7/25 5/23/83
PROCEDURE REVISION REQUEST

E. I. Hatch Nuclear Plant

RADIATION EXPOSURE LIMITS

CONTINUOUS AIR MONITORS MODELS AM-3D AND AM-33-1 OPERATION AND CALIBRATION

| PAGE NO. | 4 of 8 |

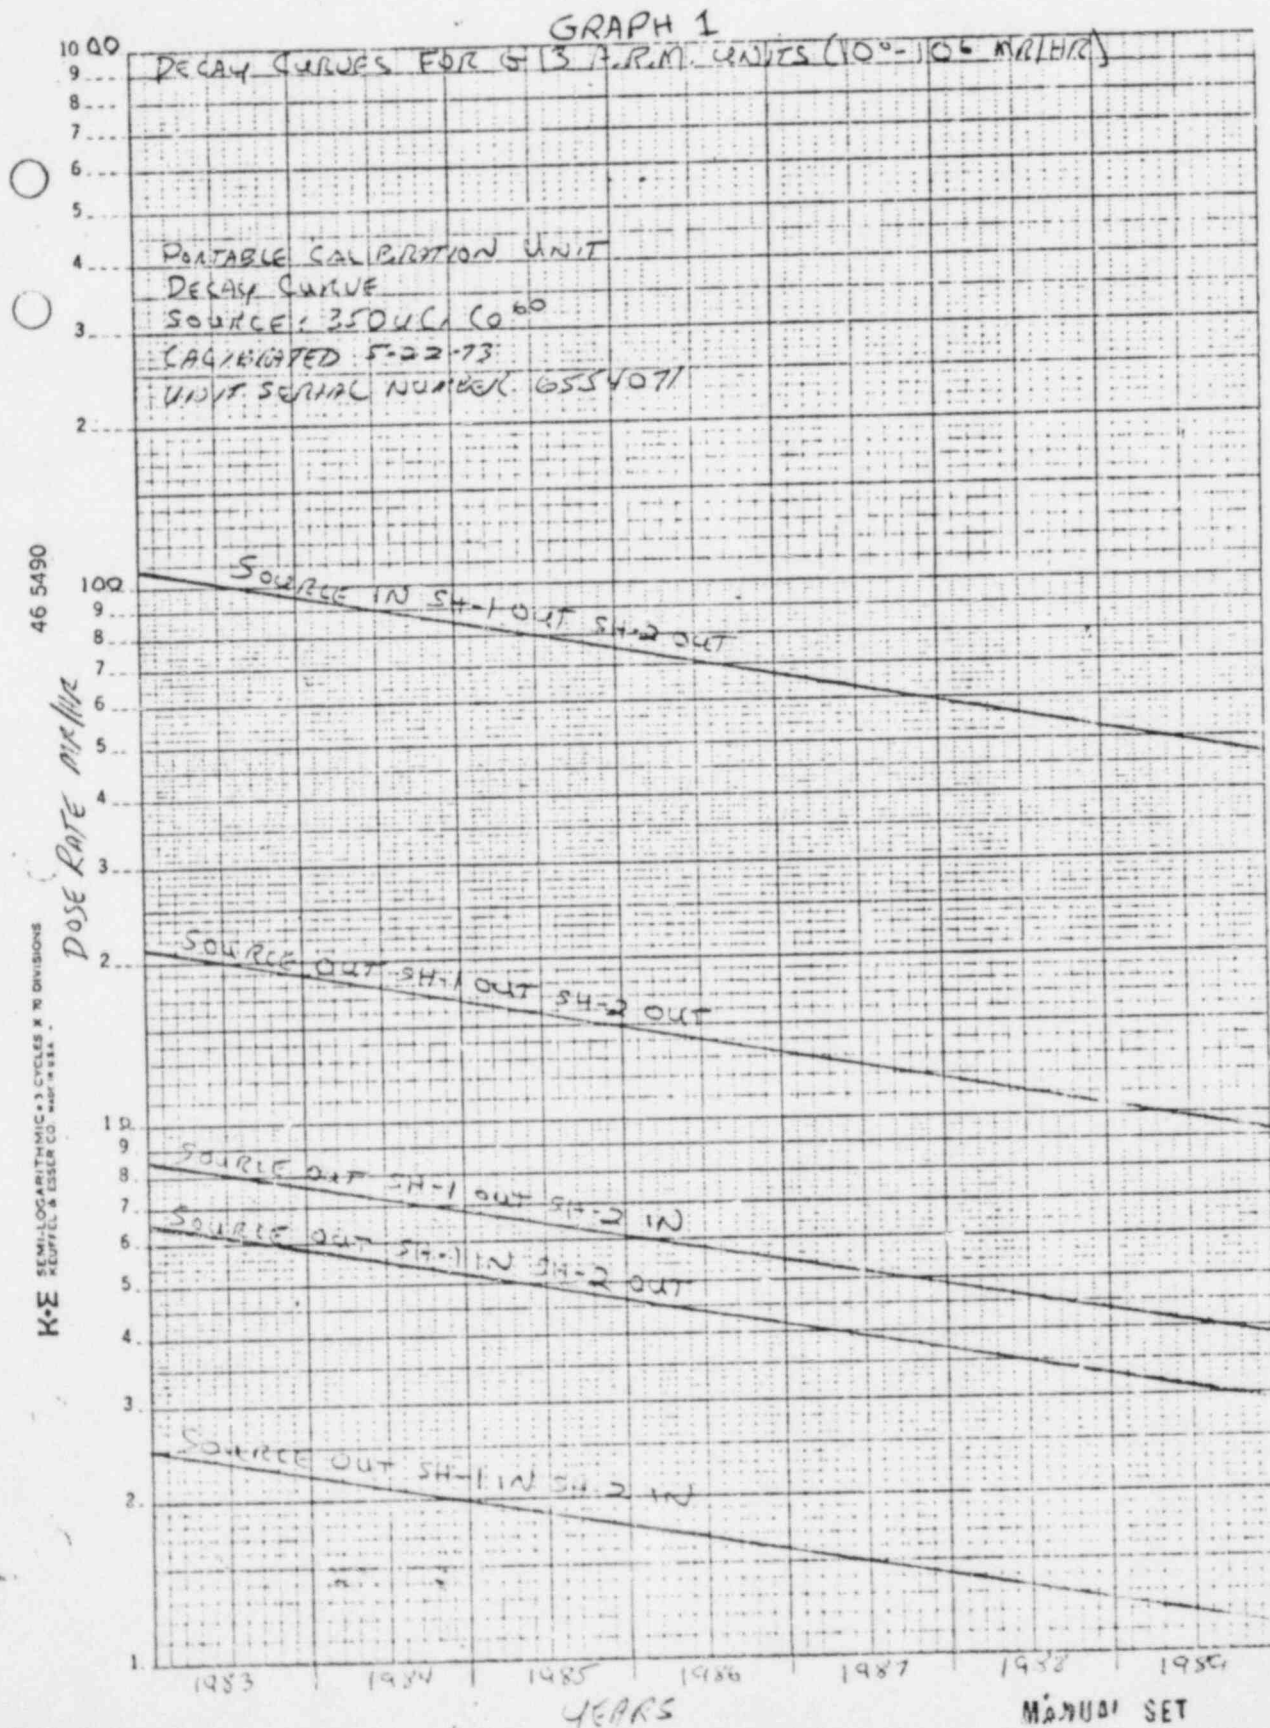
PAGE 4 GRAPH NUMBER ONE DELETE GRAPH, ADD
NEW PAGE 4 GRAPH 1. PAGE 5 GRAPH NUMBER TWO DELETE GRAPH, ADD
NEW PAGE 5 GRAPH 2. PAGE 7 GRAPH NUMBER 3 DELETE GRAPH, ADD NEW
PAGE 7 GRAPH 3. PAGE 8 GRAPH NUMBER 4 DELETE GRAPH, ADD NEW
PAGE 8 GRAPH 4. PAGE 6 FIGURE 1 ADD SERIAL NUMBER
6339537 CHANGE FIGURE 1 TO FIGURE TWO
